CASE #PL2021-42

WALSER TOYOTA BLOOMINGTON, MN

Reviewed for Code Compliance
Date: 11/04/2022
By: K. Bayer
Plan # PRBD202210606

2022 NEW BUILDING FOR:
WALSER TOYOTA
4401 AMERICAN BLVD
BLOOMINGTON, MINNESOTA

NOTES

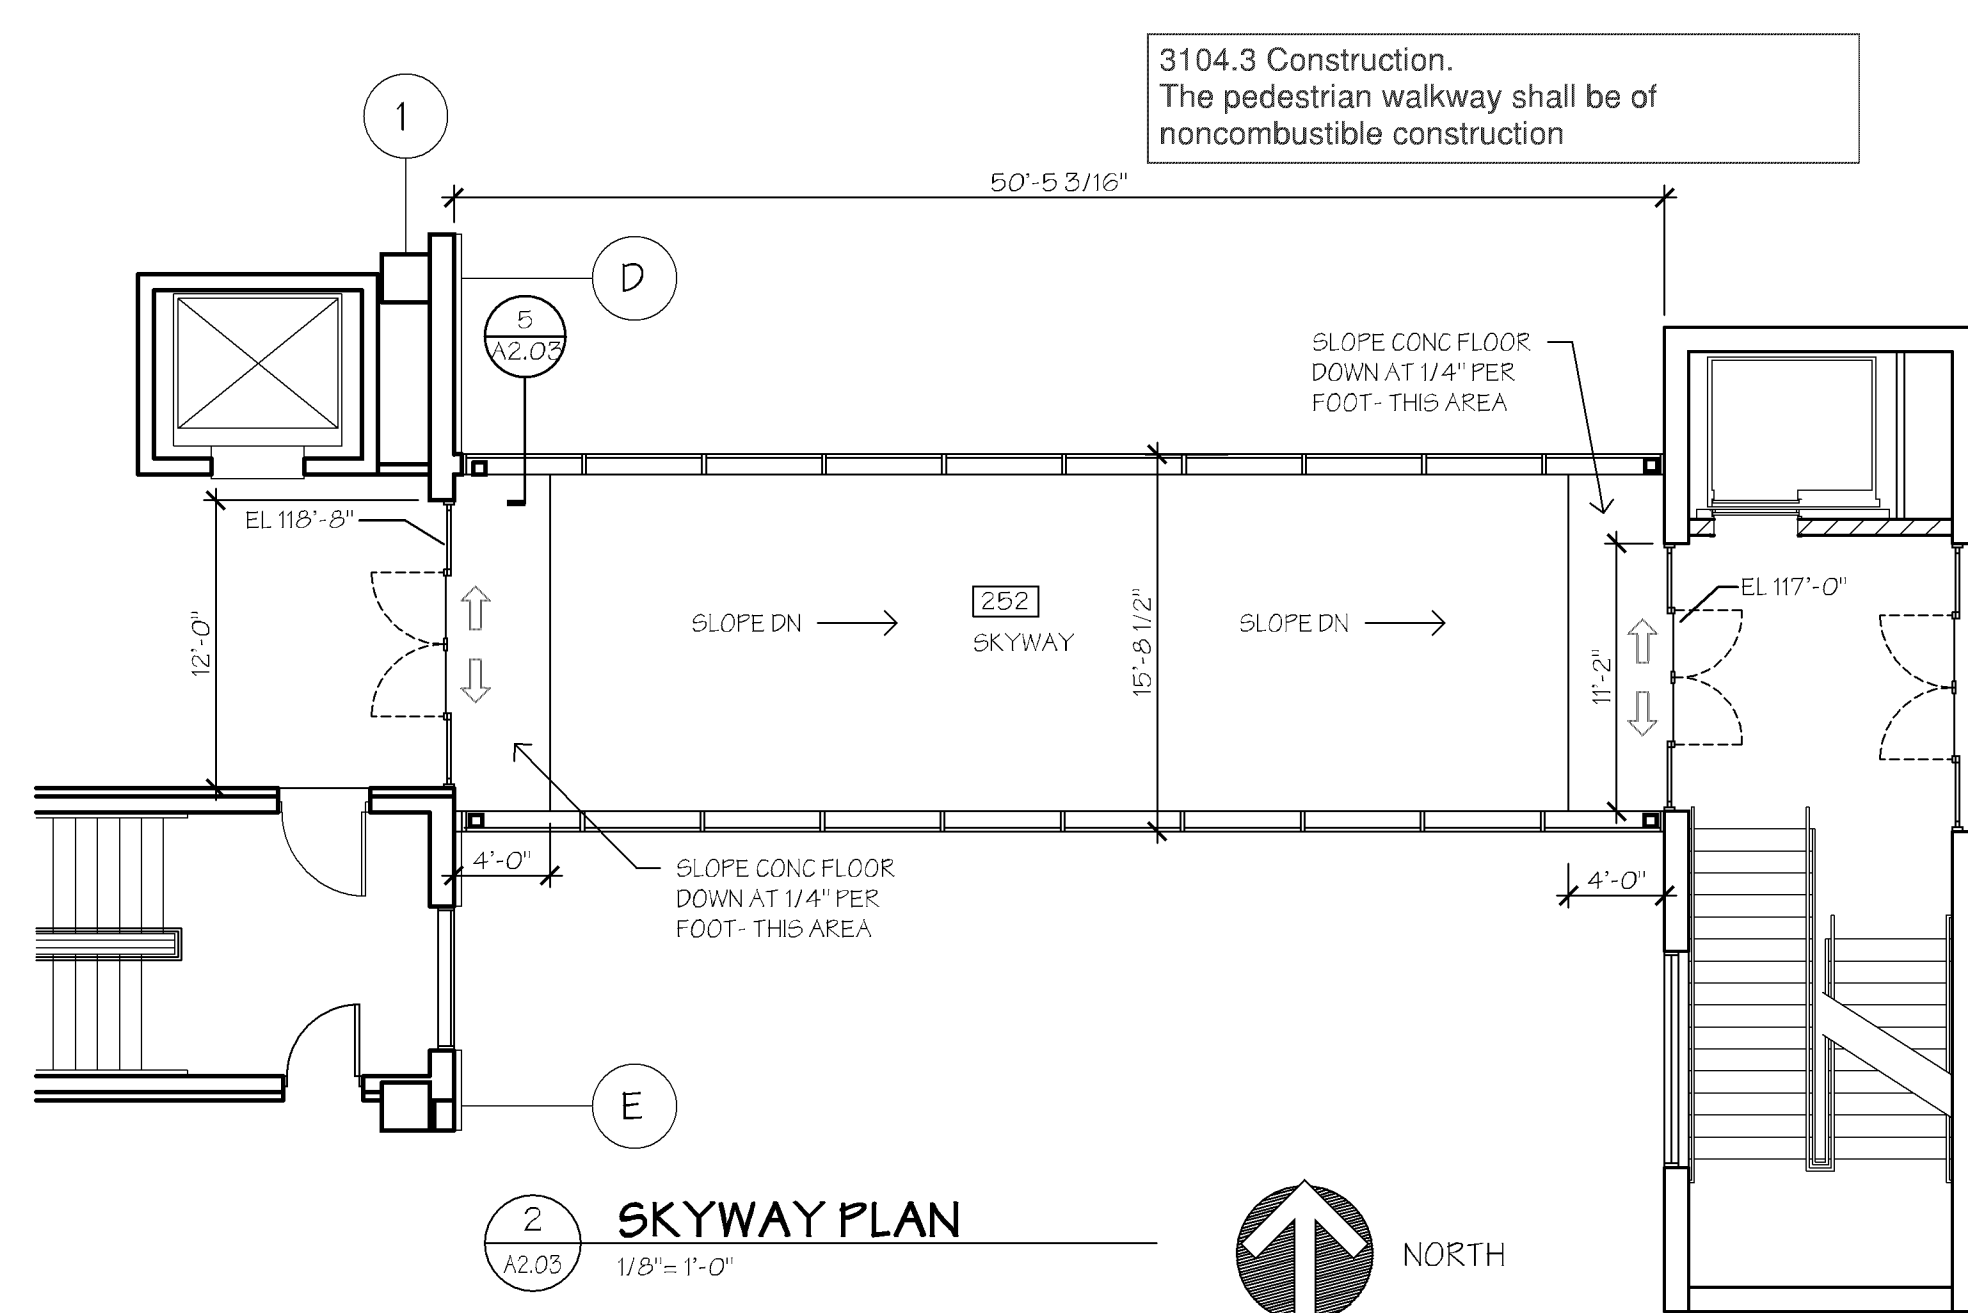
The Pedestrian Walkway shall comply with all requirements of Section 3104 of the 2020 MN Building Code.

1 SECOND FLOOR PLAN
1/8" = 1'-0"

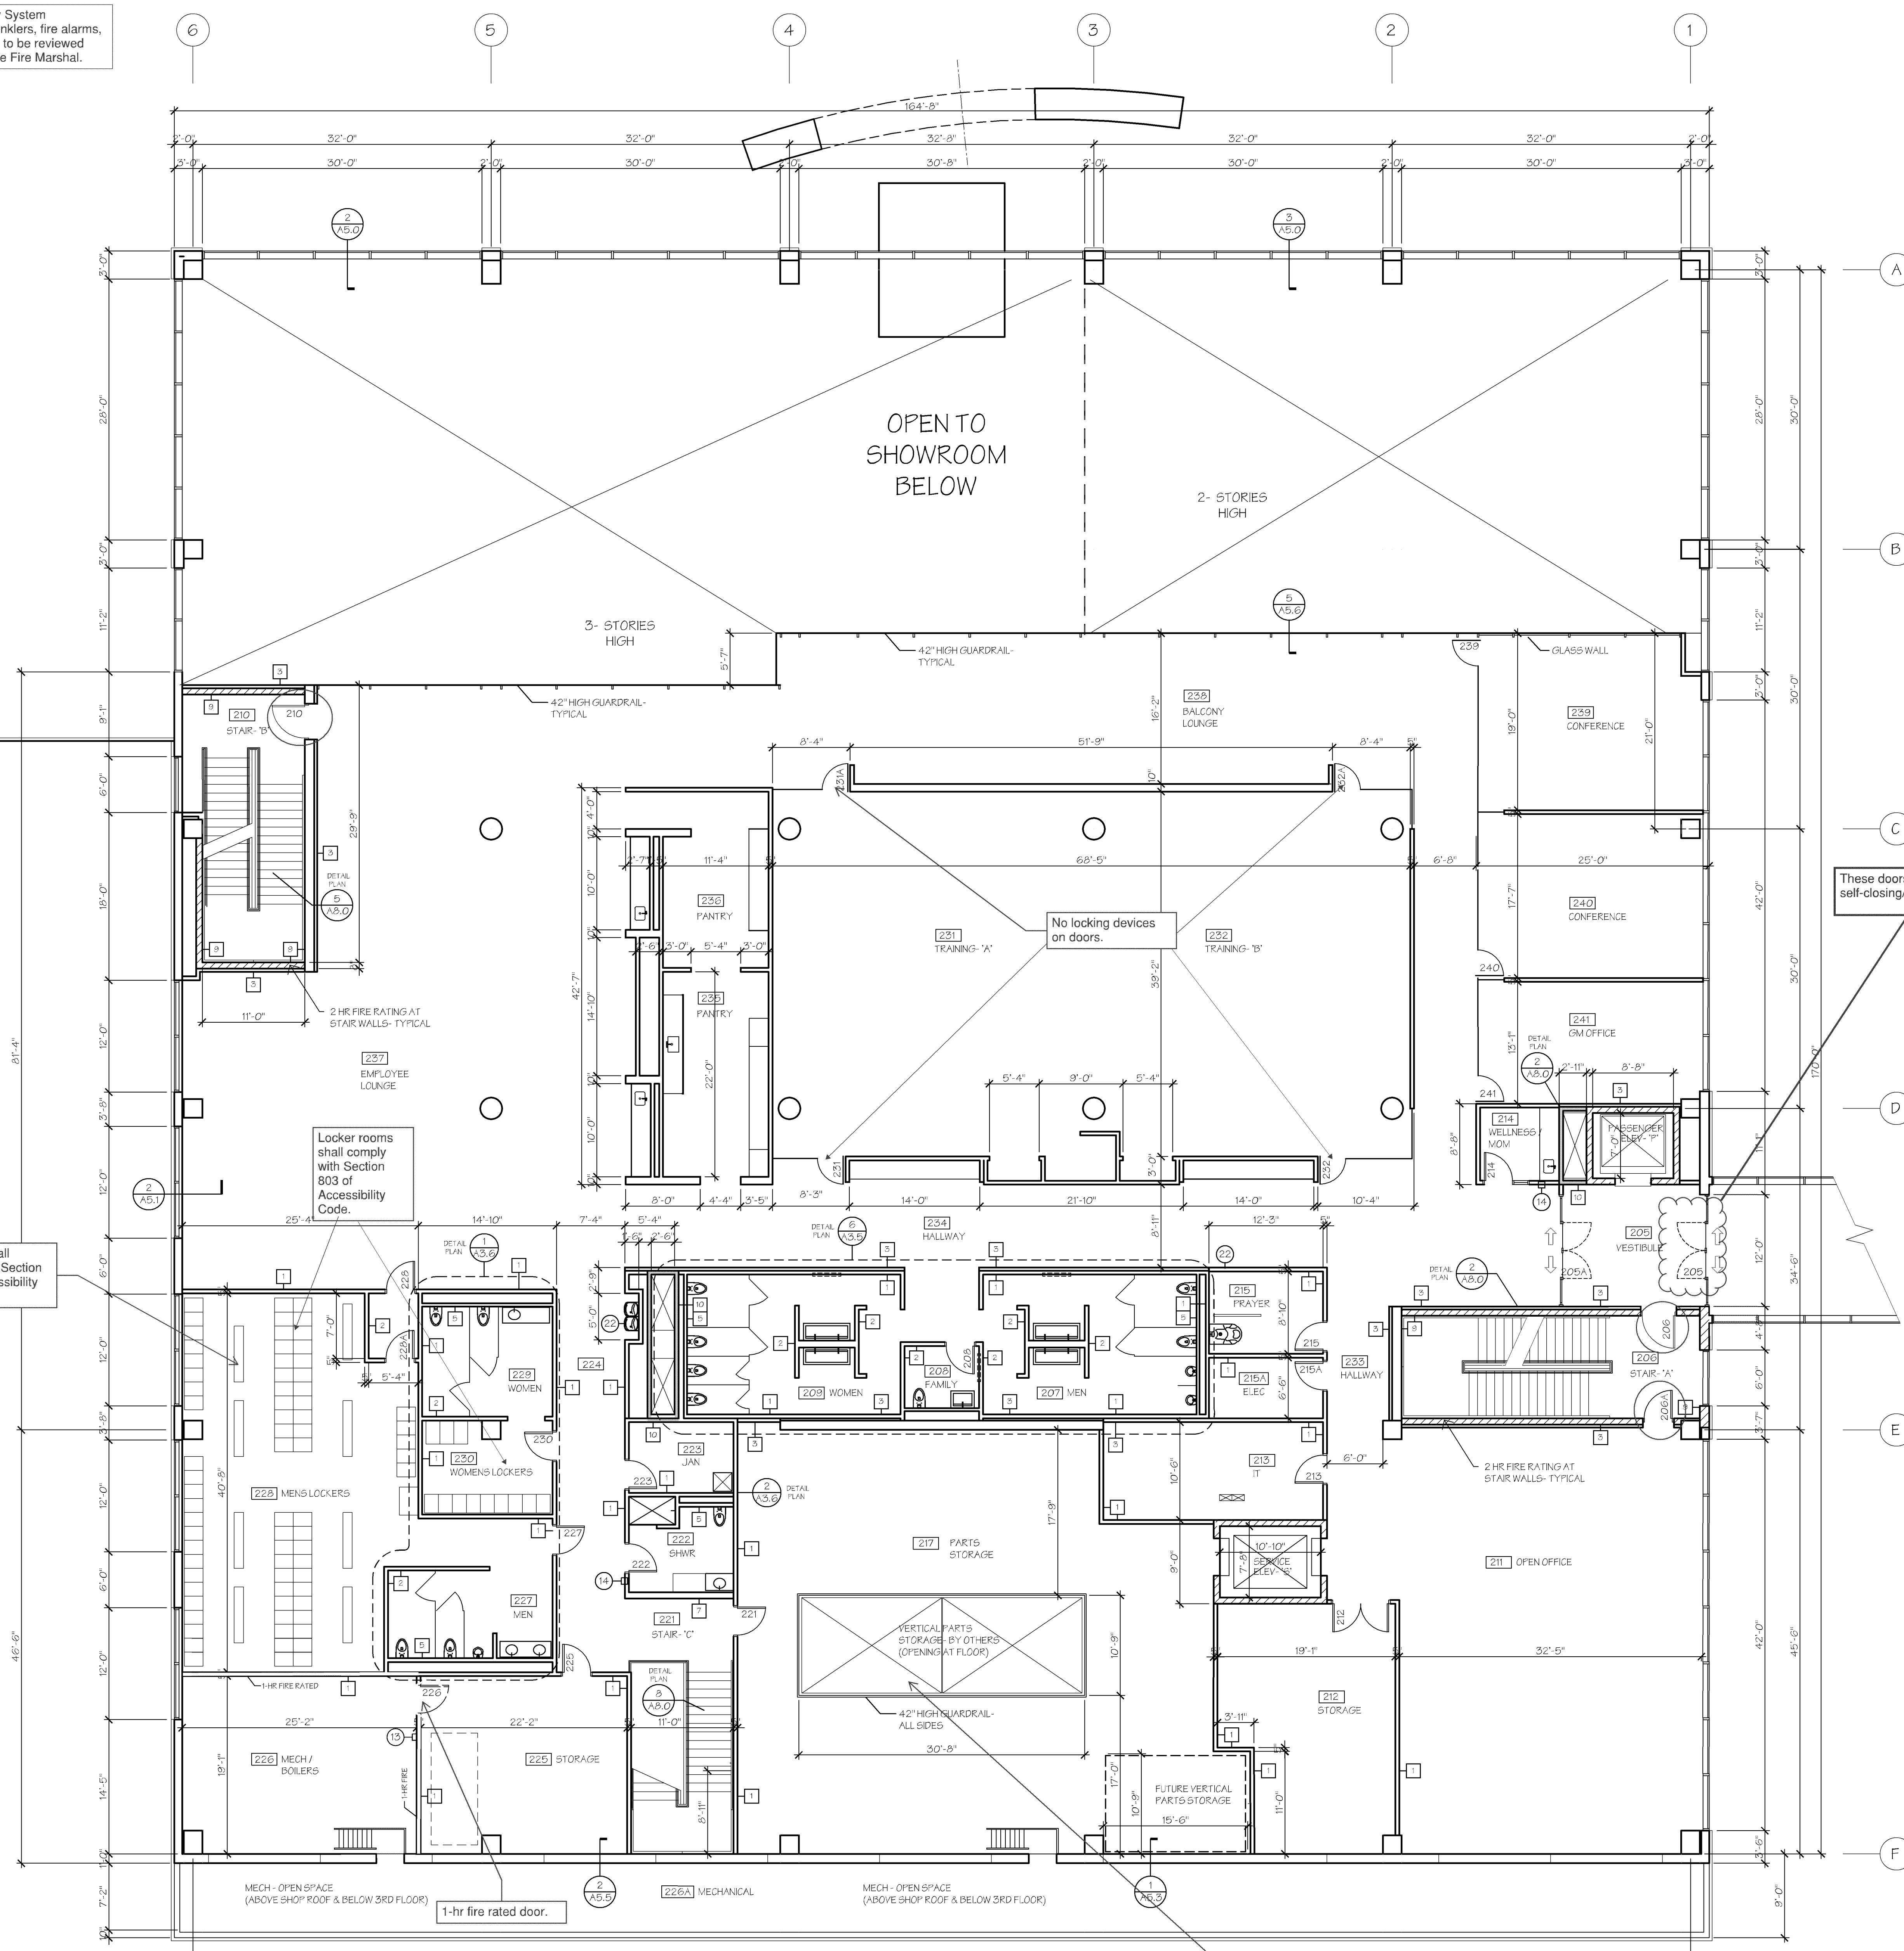
All construction materials shall be non-combustible.
Maximum flame spread allowable for all finishes = 200.
Provide Sprinkler protection as approved by the Fire Marshal.
No combustibles shall be allowed in air plenums.

Fire and Life Safety System Requirements (Sprinklers, fire alarms, horns, strobes, etc) to be reviewed and approved by the Fire Marshal.

Benches shall comply with Section 903 of Accessibility Code.

Any elevator, lift, or conveyor shall be reviewed and approved by State of MN.

1 THIRD FLOOR PAN
1/8" = 1'-0" NORTH

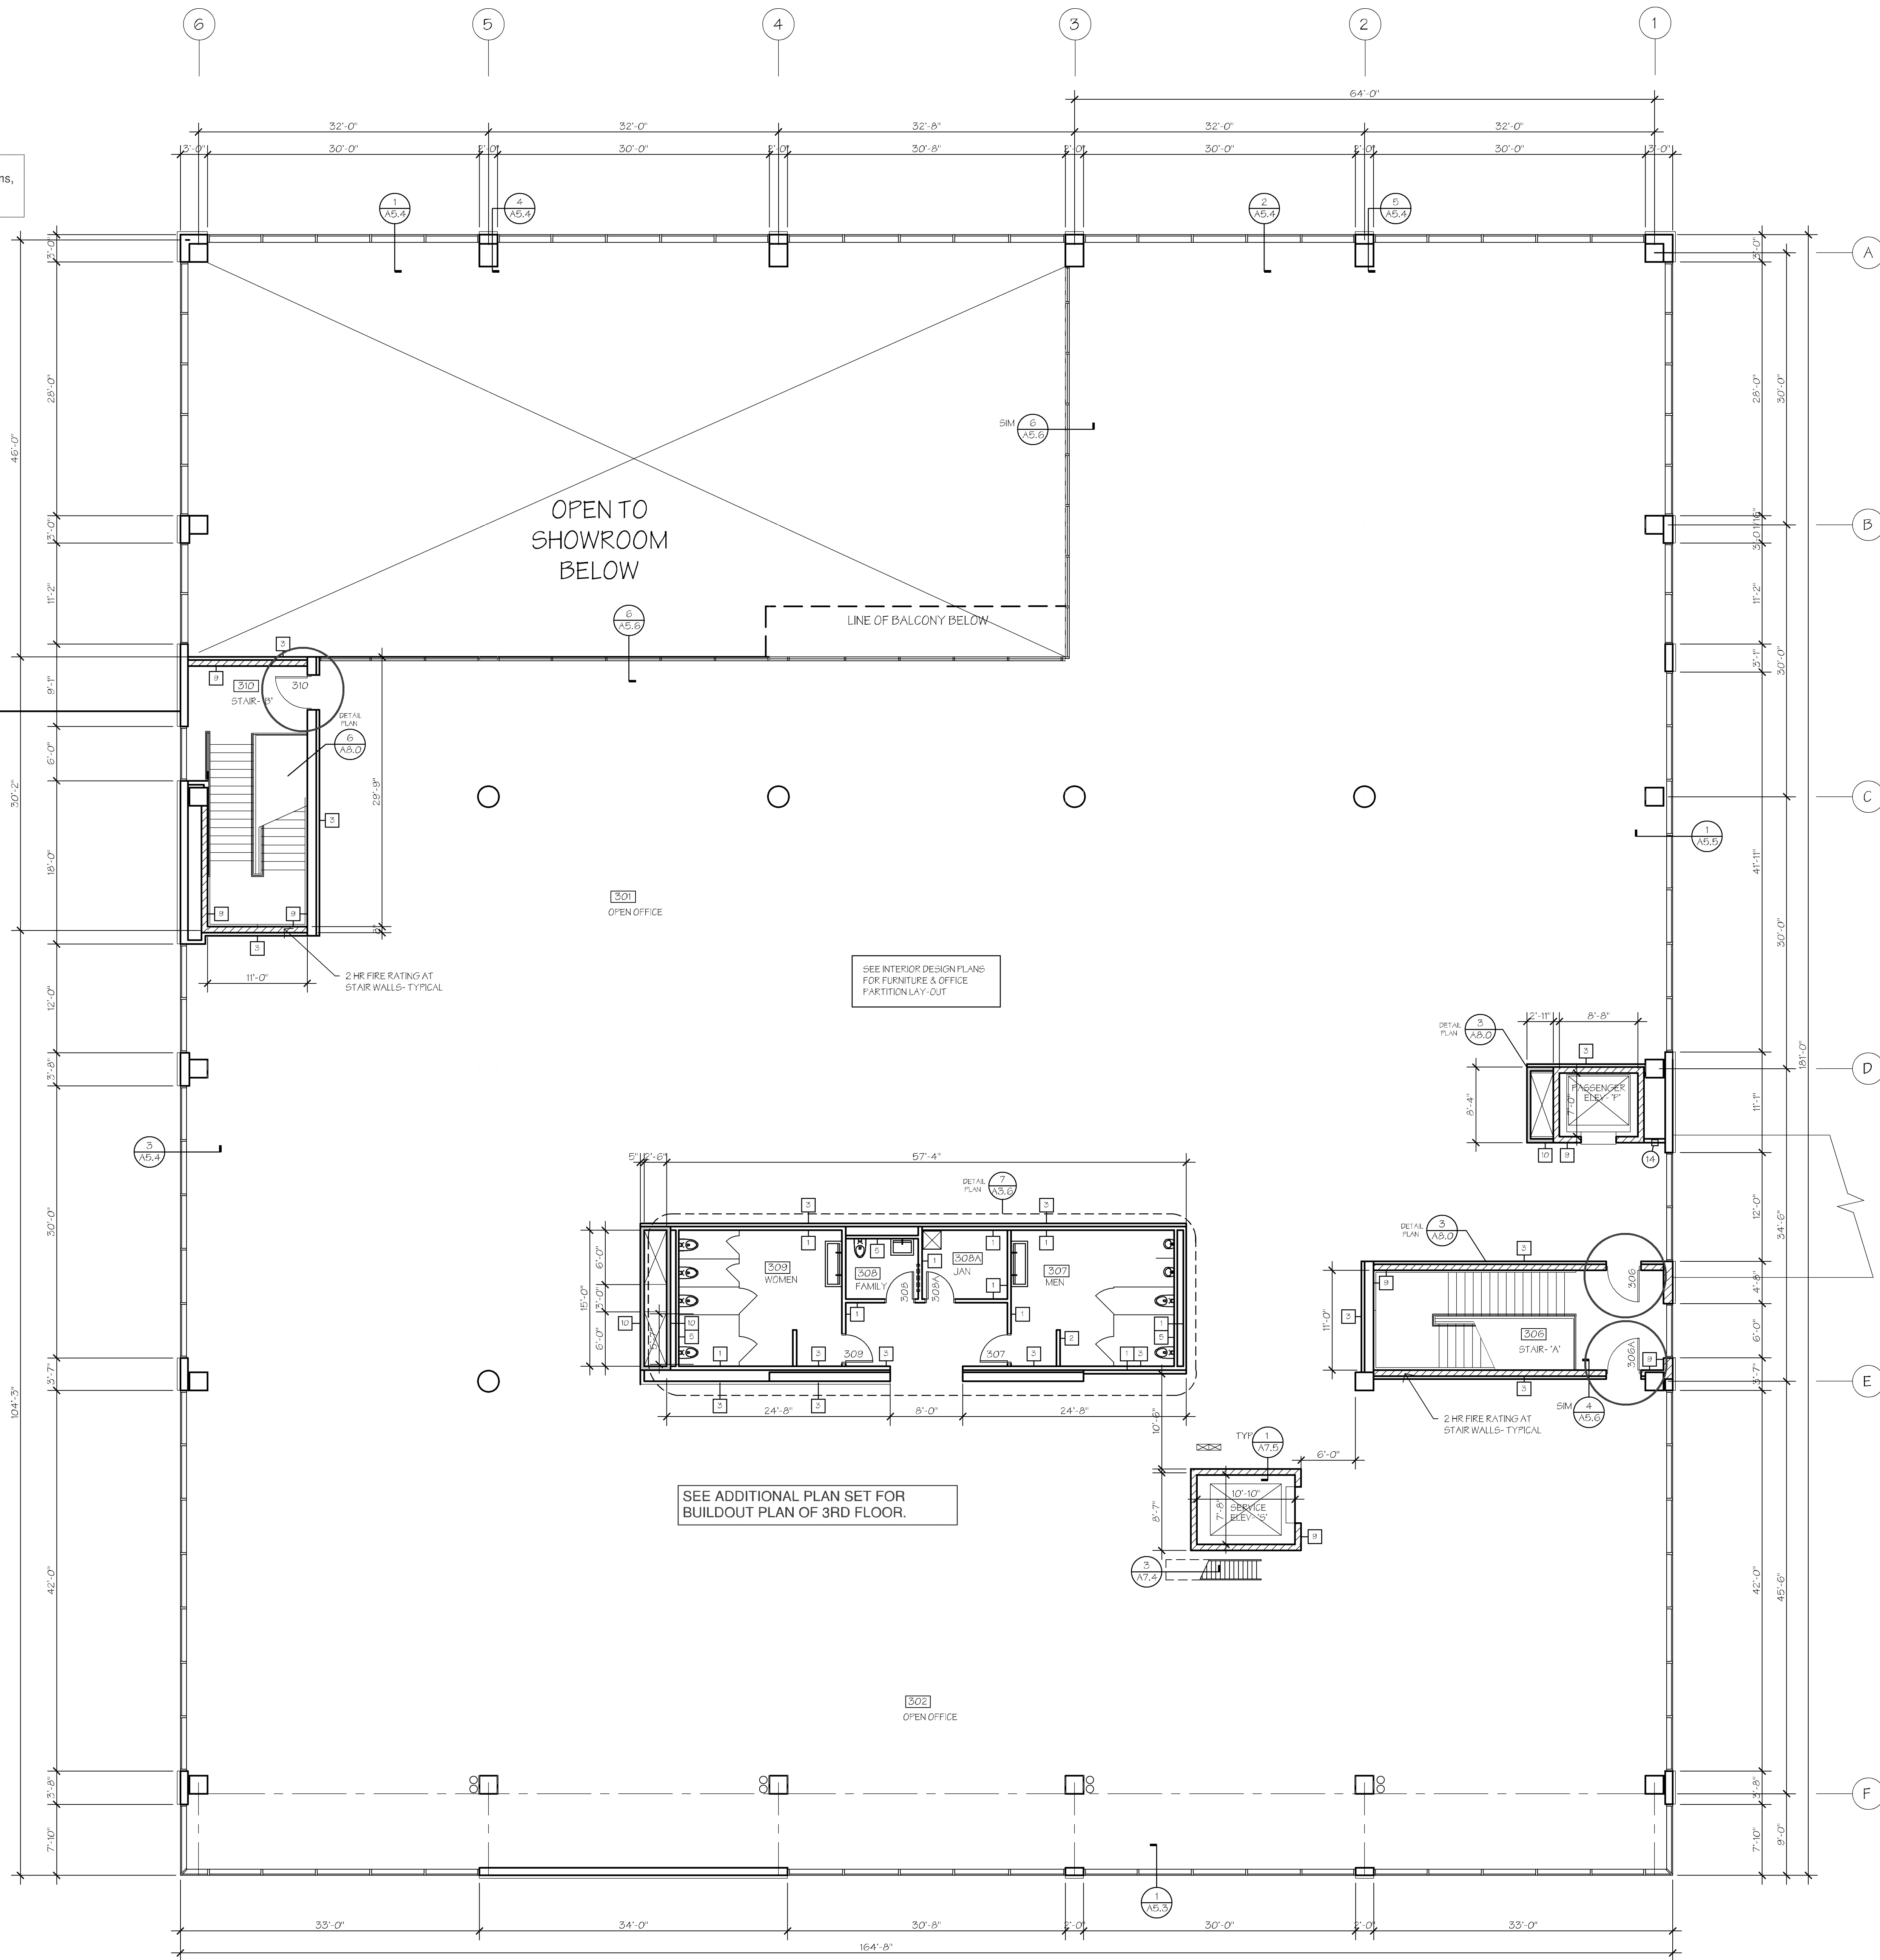
All construction materials shall be non-combustible.
Maximum frame spread allowable for all finishes = 200.
Provide Sprinkler protection as approved by the Fire Marshal.
No combustibles shall be allowed in air plenums.

Fire and Life Safety System Requirements (Sprinklers, fire alarms, horns, strobes, etc) to be reviewed and approved by the Fire Marshal.
